IN THE DRAWINGS:

REMARKS

Patent
42526-2800

FIG. 2

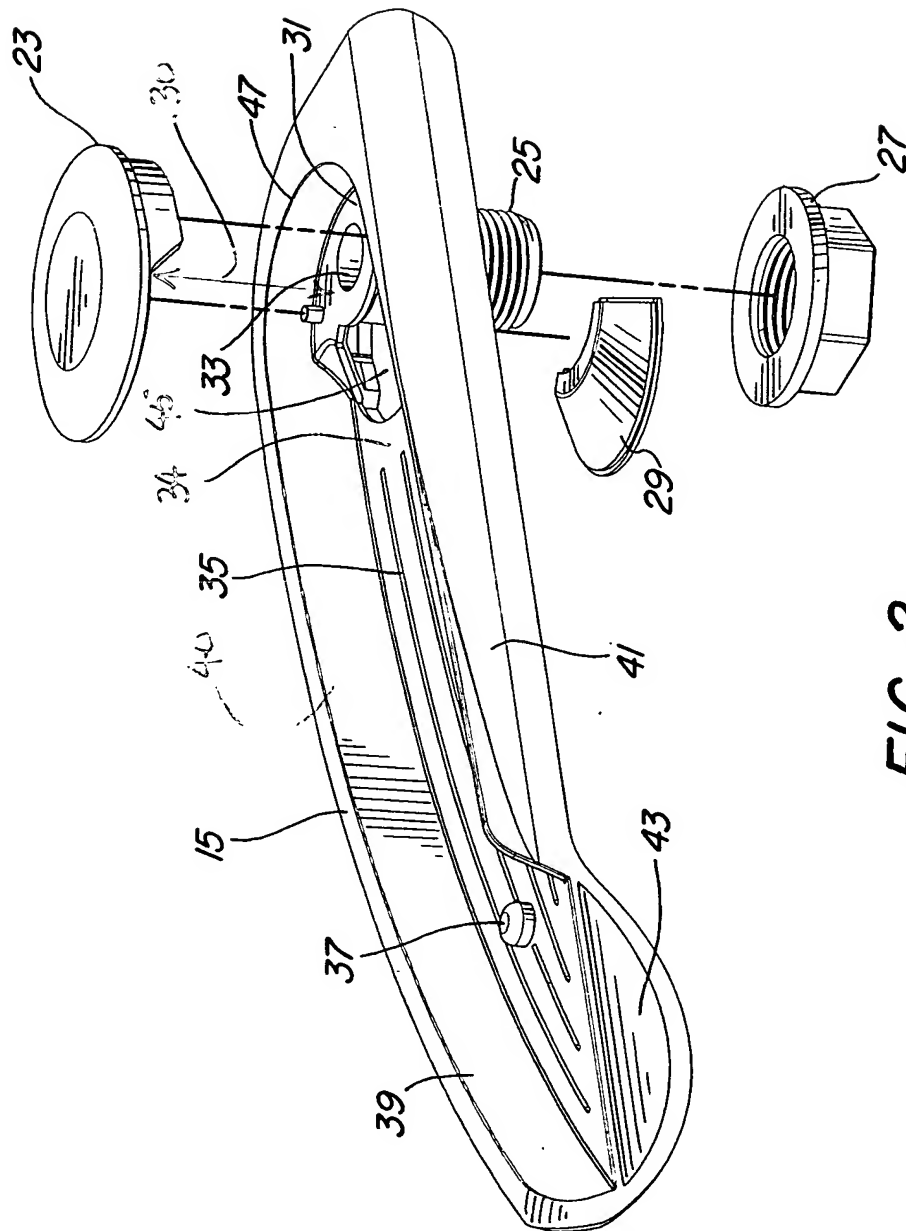
Applicant requests amendment of Figures 2, 3, 4, 5 and 7 as indicated in red on the enclosed amended sheets.

Reference numerals have been added to Figures 2, 3, 4, 5 and 7. In addition, the reference numeral 39 in Figures 3 and 4 has been changed to 40 to conform with the specification.

FIG. 5

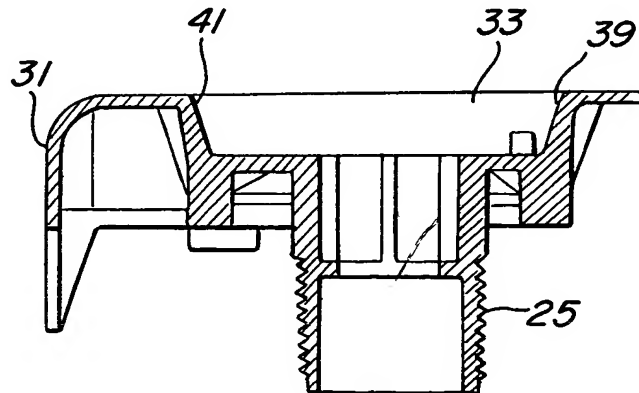
Figure 5 was objected to for improper material cross-hatching. Applicant respectfully traverses. The cross-hatching is not for the purpose of showing the material type, i.e. plastic.
